REMARKS

AMENDMENTS TO THE DRAWINGS

ANNOTATED
MARKED-UP
DRAWINGS

FIG. 2
PRIOR ART

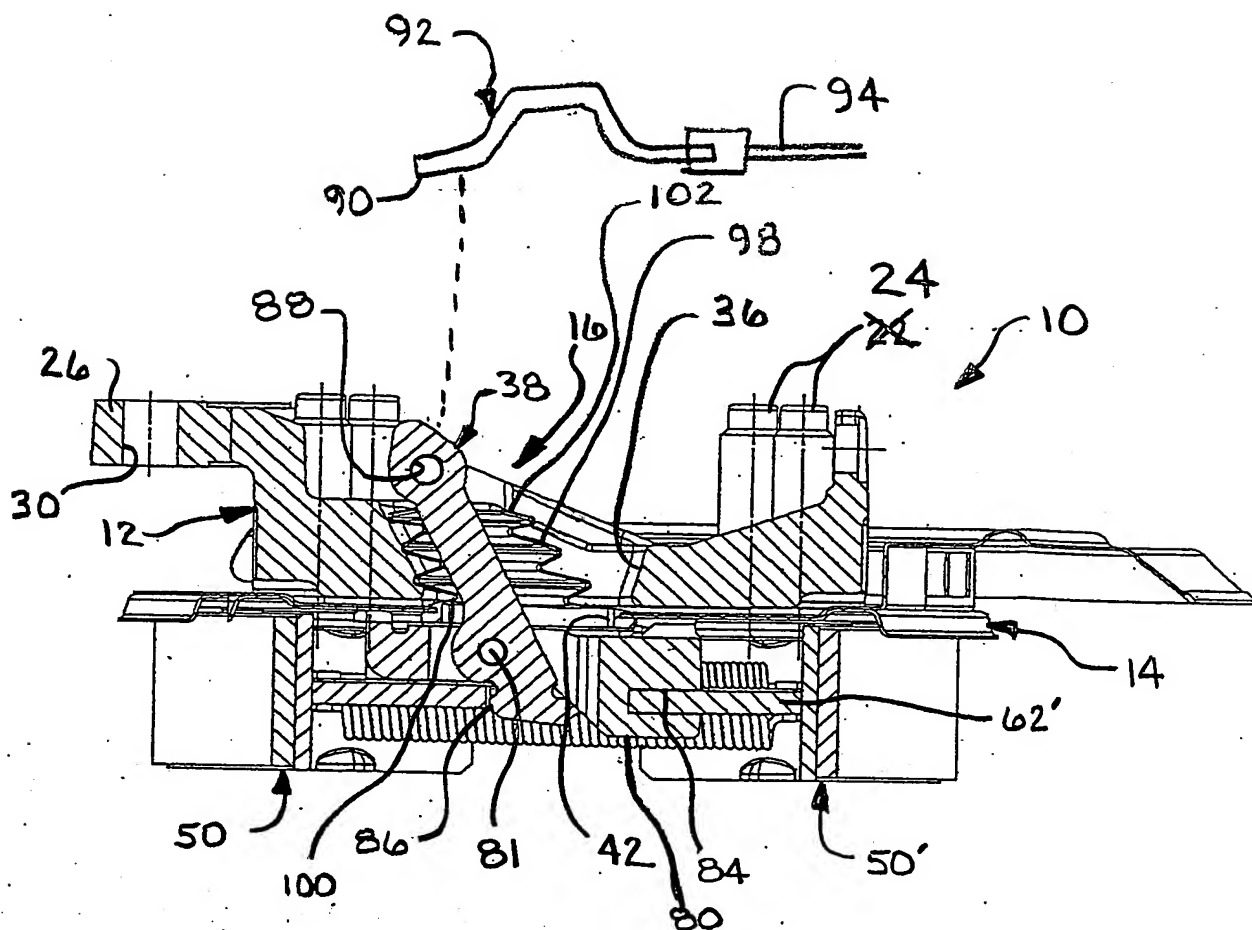
Please amend the drawings as follows: drawing Fig. 2 by changing reference character 22 to 24 and adding reference character 81; drawing Fig. 3 by adding reference character 138; and drawing Fig. 4 by adding arrow and label “pulling direction”, as shown in red on the attached drawing sheets. Attached herewith are “Replacement Sheets” of Figs. 2, 3 and 4 and “Annotated Marked-Up Drawings” of Figs. 2, 3 and 4. No new matter has been added. Formal drawings will be submitted upon approval of these changes and issuance of a Notice of Allowance.
